NOTICE OF DENIAL

RE: Application Number 22-8057; 691 W. Canfield; West Canfield Historic District

CERTIFICATE OF APPROPRIATENESS

691 W Canfield SCOPE OF WORK

NORTH ELEVATION
"FRONT"

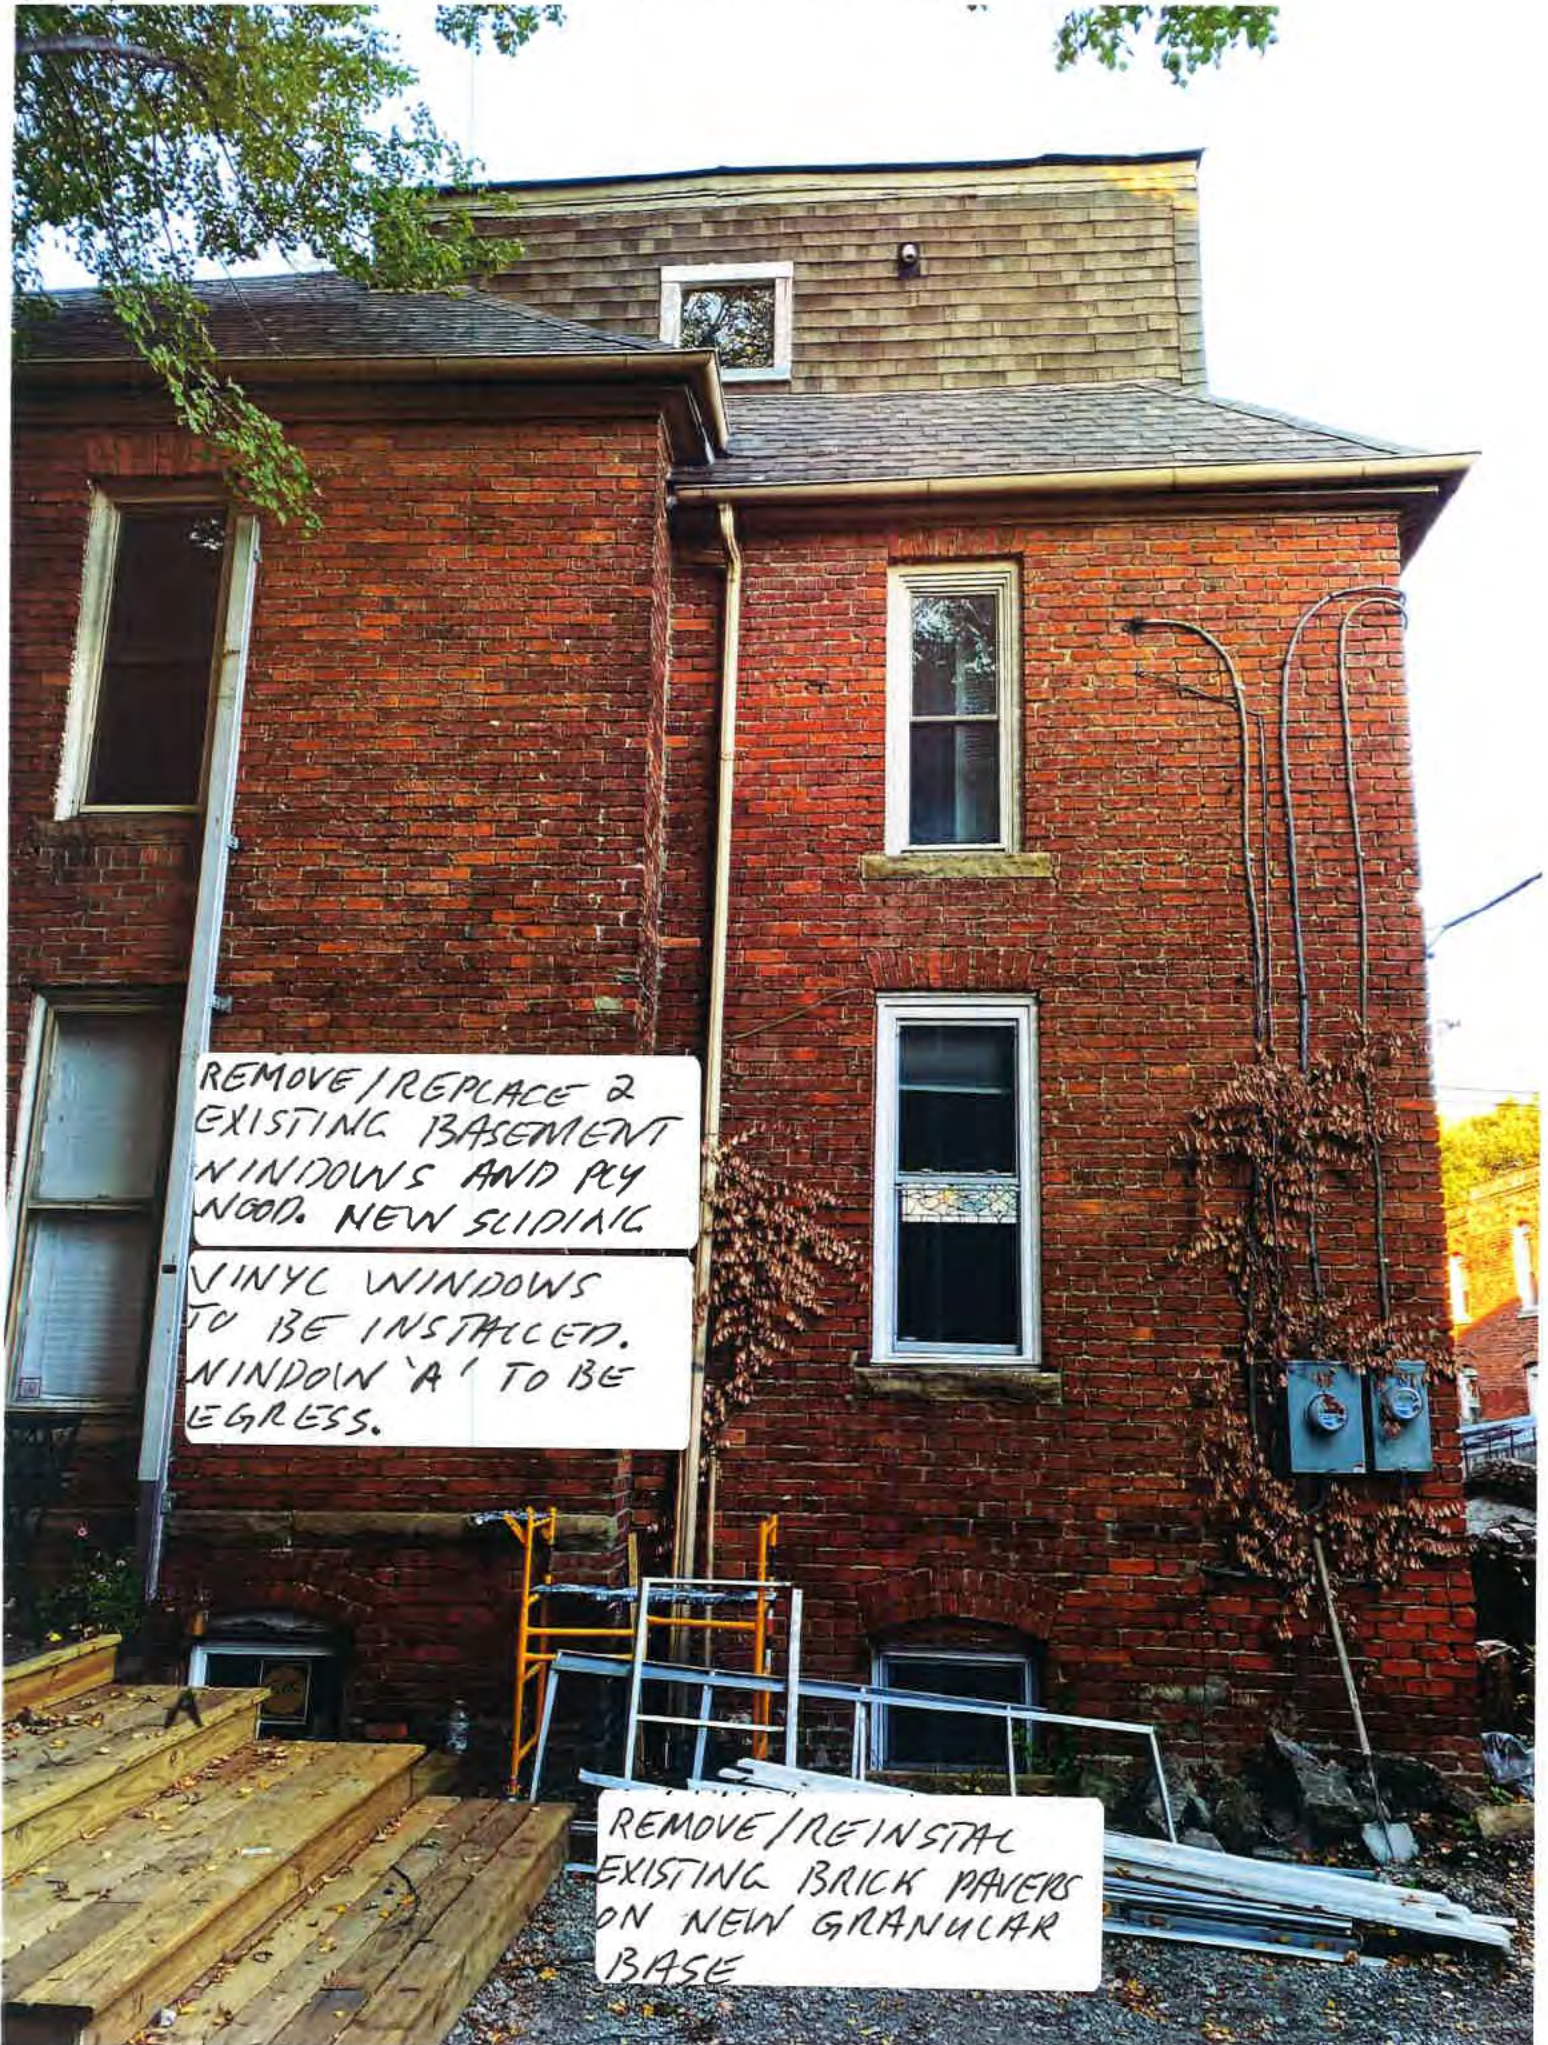
REMOVE EXISTING MOSS COVERED ASPHALT ROOF SHINGLES ON PORCH. REPLACE WITH NEW ASPHALT SHINGLES TO MATCH UPPER ROOF

REMOVE EXISTING SLIDING VINYL BASEMENT WINDOW LOWER SILL 10" AND PROVIDE NEW SINGLE HUNG VINYL EGRES WINDOW

PROVIDE 6X6 PTW WINDOW WELL TO SUIT. REPLACE EXISTING WOOD TRIM TO MATCH.

6' METAL PICKET FENCE TO CLOSE OFF EAST SIDEYARD. GATED FOR ACCESS

SOUTH ELEVATION
1 OF 3

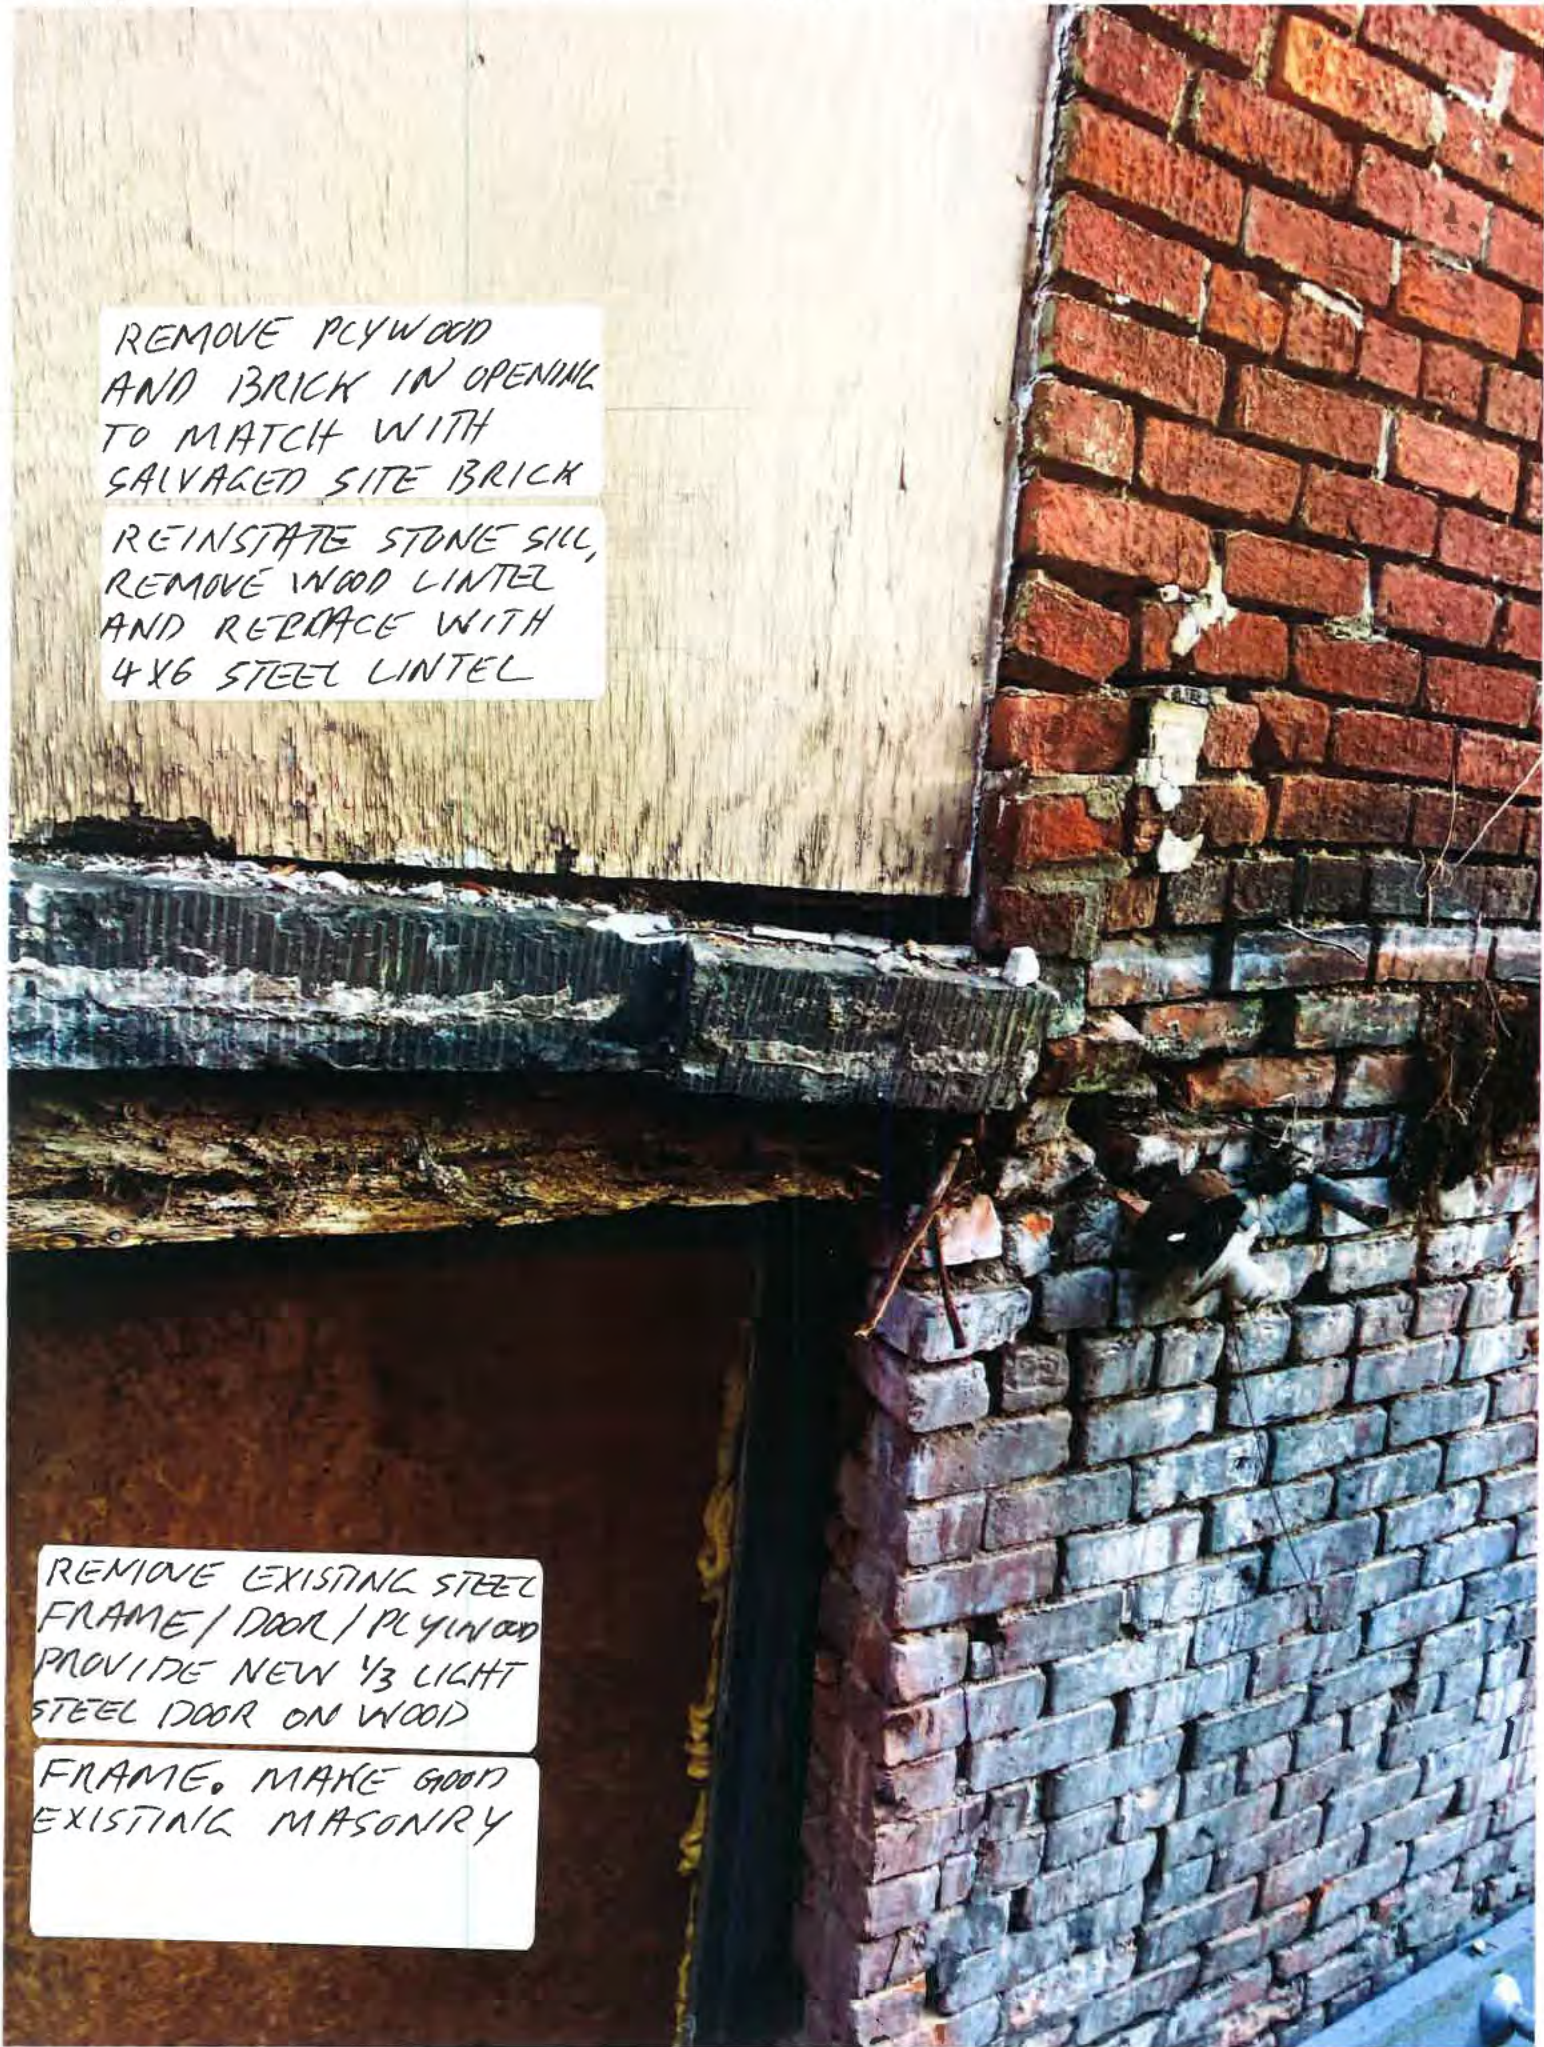
REMOVE PLYWOOD
AND BRICK IN OPENING
TO MATCH WITH
SALVAGED SITE BRICK

REINSTATE STONE SILL,
REMOVE WOOD LINTEL
AND REPLACE WITH
4X6 STEEL LINTEL

REMOVE EXISTING STEEL
FRAME / DOOR / PLYWOOD
PROVIDE NEW 1/3 LIGHT
STEEL DOOR ON WOOD

FRAME. MAKE GOOD
EXISTING MASONRY

REMOVE PLYWOOD AND
BRICK IN RIGHT SIDE
WINDOW TO MATCH.
EXTEND LEFT WINDOW

SILL DOWN 18" AND
PROVIDE VINYL SINGLE
HUNG WINDOW. MAKE
GOOD MASONRY OPENING

EAST ELEVATION 1 OF 2

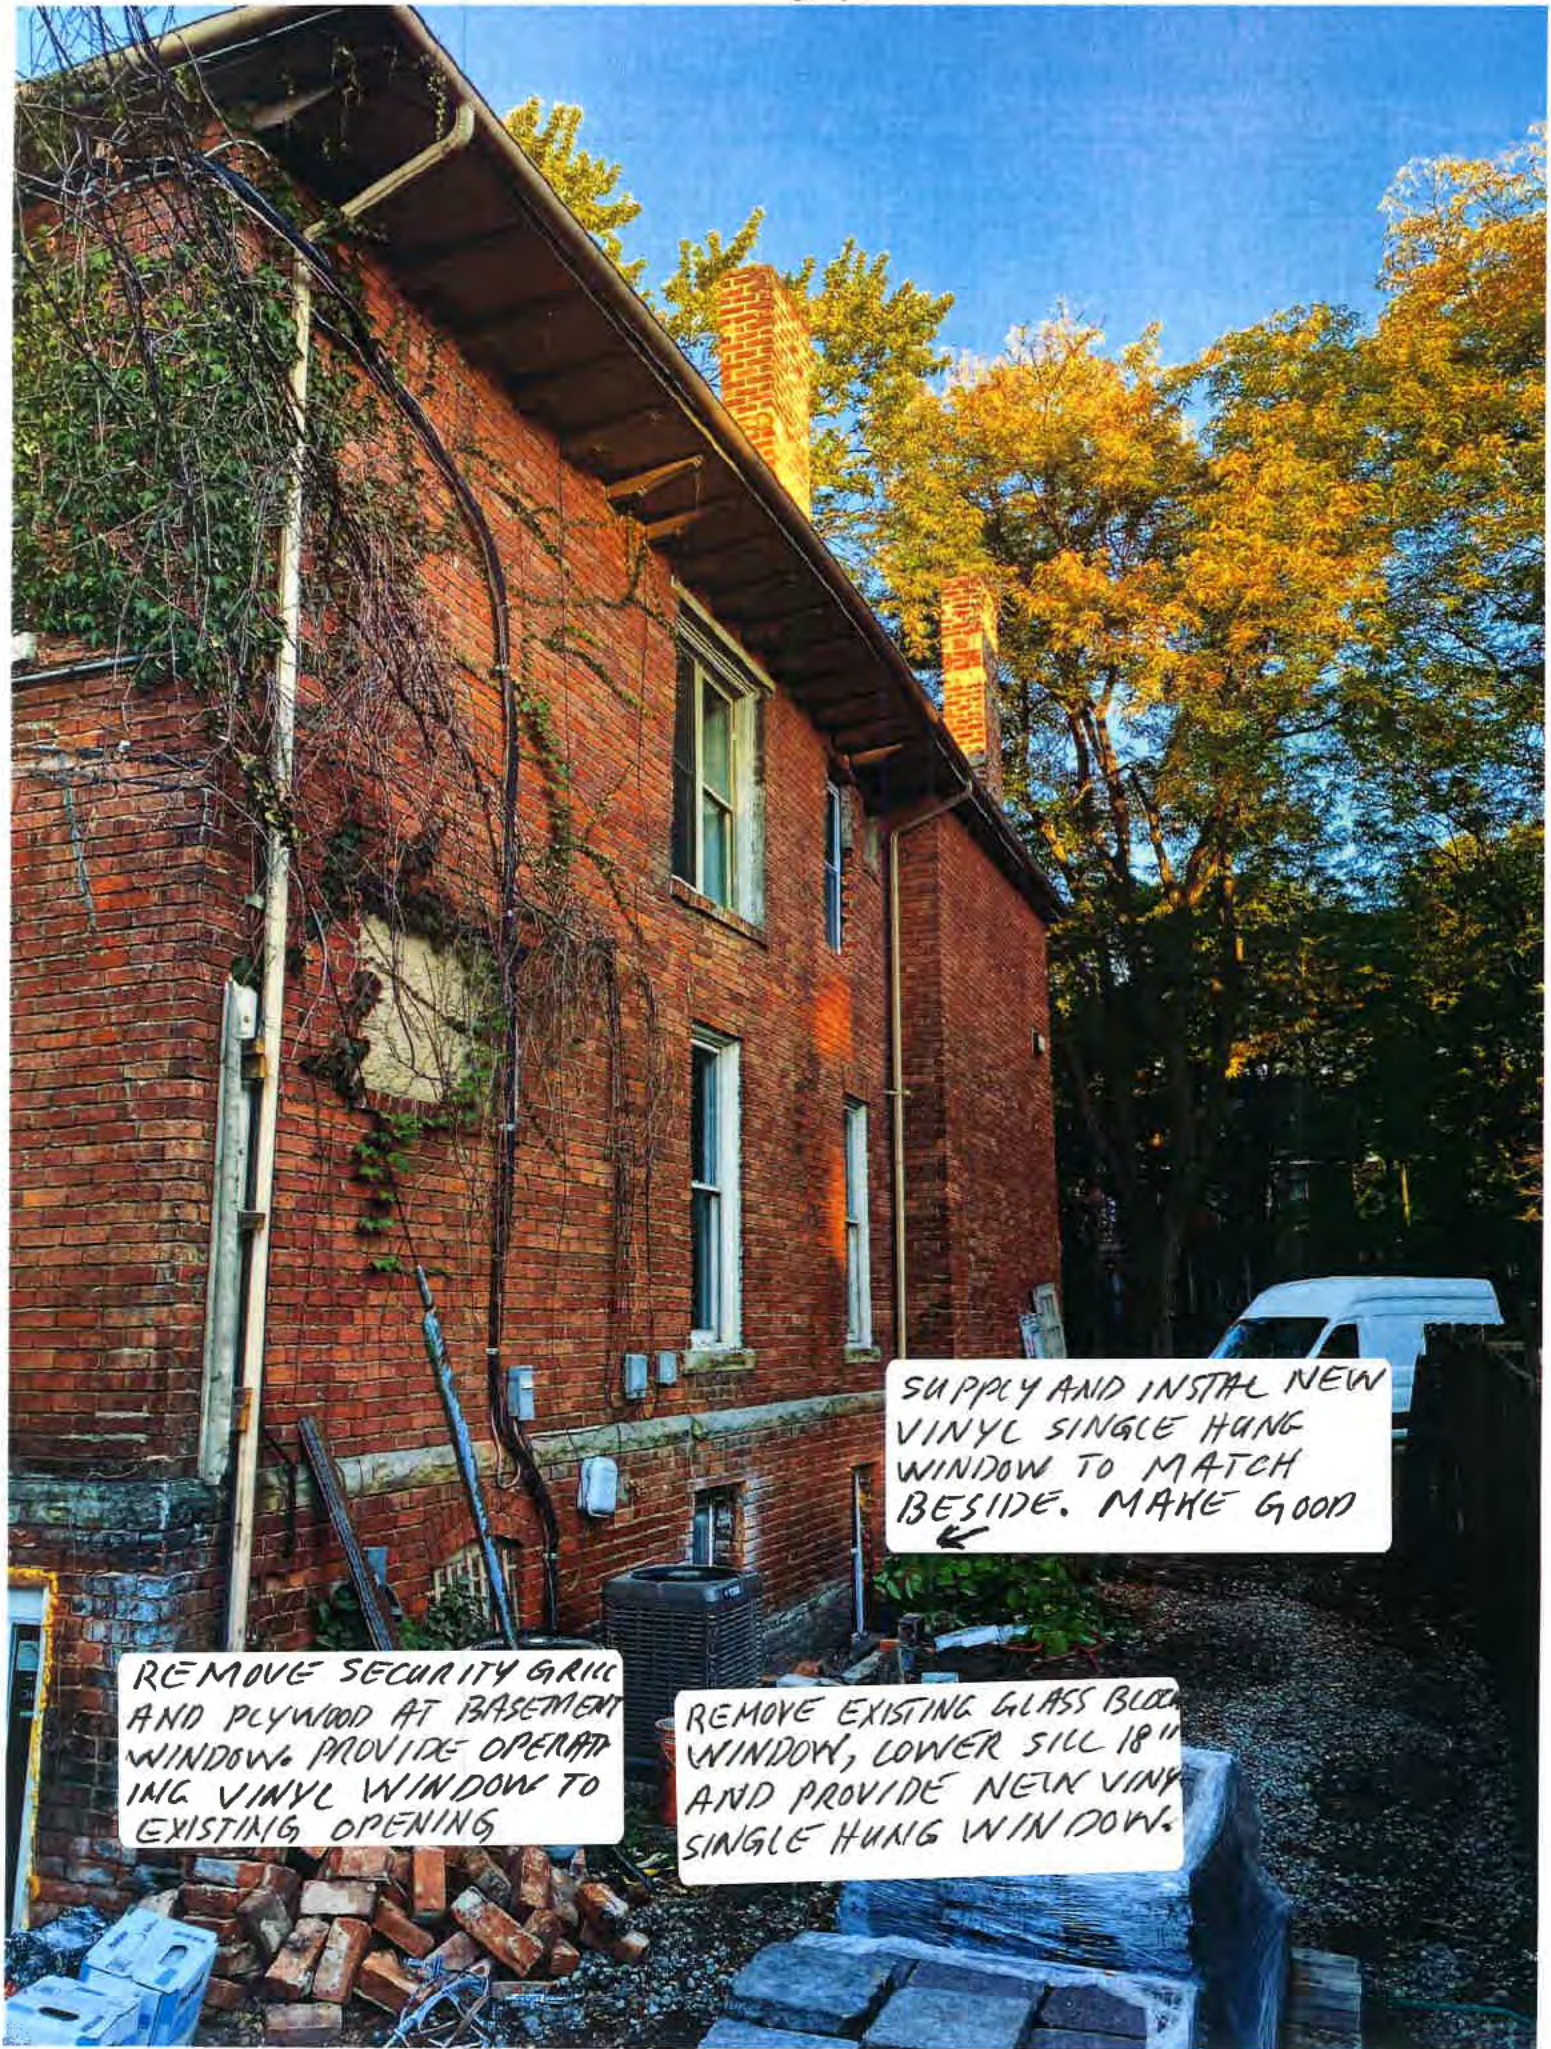
SUPPLY AND INSTAL NEW VINYL SINGLE HUNG WINDOW TO MATCH BESIDE. MAKE GOOD
←

REMOVE SECURITY GRILL AND PLYWOOD AT BASEMENT WINDOW. PROVIDE OPERATING VINYL WINDOW TO EXISTING OPENING

REMOVE EXISTING GLASS BLOCK WINDOW, LOWER SILL 18" AND PROVIDE NEW VINYL SINGLE HUNG WINDOW.
